From: Ken Scarola <KenScarola@NuclearAutomation.com>
Sent: Friday, April 21, 2017 1:10 PM
To: Drake, Jason
Cc: Rahn, David; Holonich, Joseph; Morton, Wendell
Subject: [External_Sender] Recommendations and Comments on Staff Documents Issued in Conjunction with April 20, 2017 Public Meeting on CCF RIS
Attachments: Draft_RIS_to_Clarify_RIS_2002-22_Endorsement_of_NEI_01-01 for Public Meeting on 04-20-2017 Change Accepted_KS.docx; Qualitative Assessment Guidance for NEI 01-01_rev1 Changes Accepted for use with 04-20-2017 Public Meeting --Changes Accepted_KS.docx

**NRC REGULATORY ISSUE SUMMARY 2017-XX
UPDATE TO THE STAFF ENDORSEMENT ON THE USE OF
EPRI/NEI JOINT TASK FORCE REPORT,
“GUIDELINE ON LICENSING DIGITAL UPGRADES: EPRI TR-102348,
REVISION 1, NEI 01-01: A REVISION OF EPRI TR-102348 TO
REFLECT CHANGES TO THE 10 CFR 50.59 RULE”
(REPORT PREVIOUSLY ENDORSED WITHIN RIS 2002-22)**

Draft – Qualitative Digital I&C change Assessment Framework

Figure 1 - RIS Decision Tree Flowchart

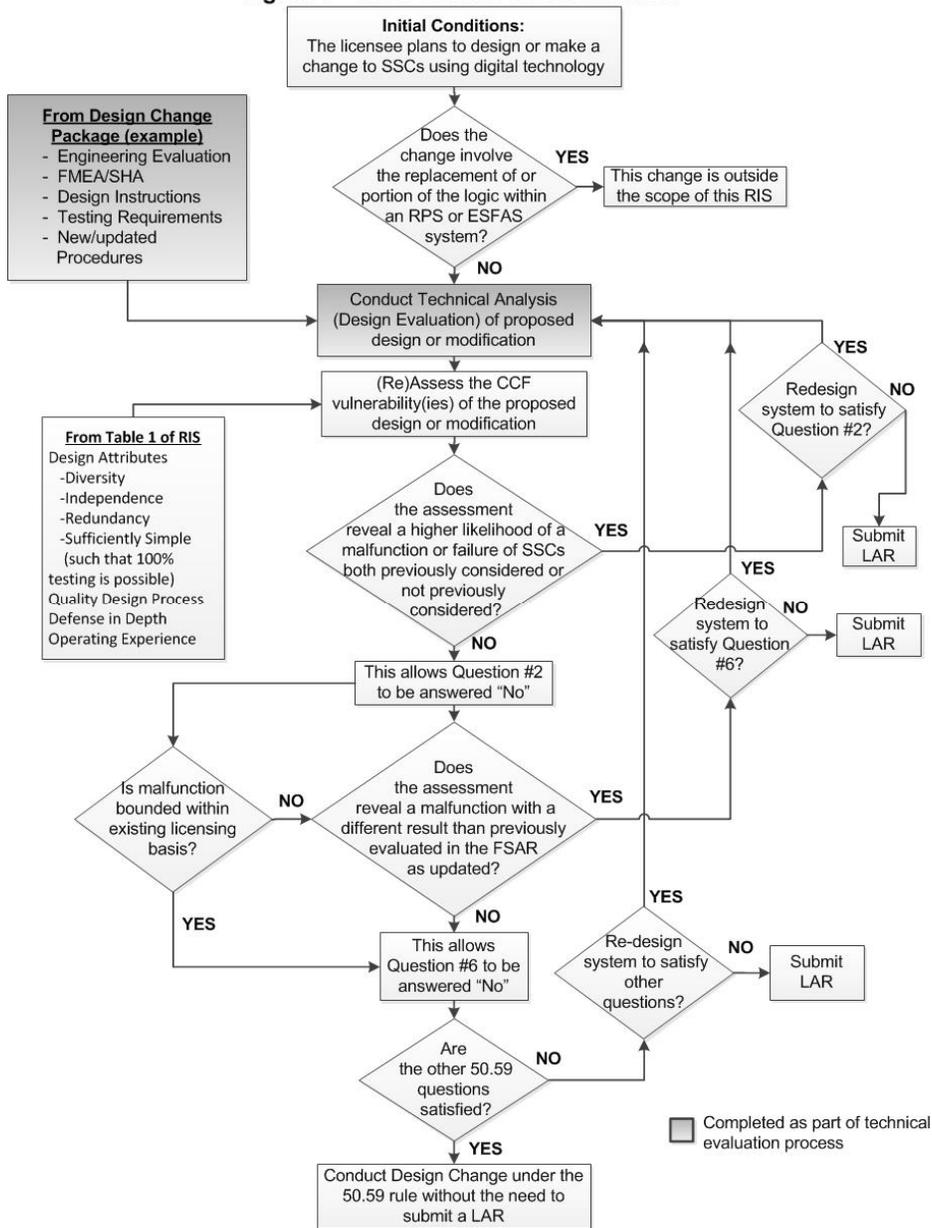
[see separate PDF file for comments on the figure above.]
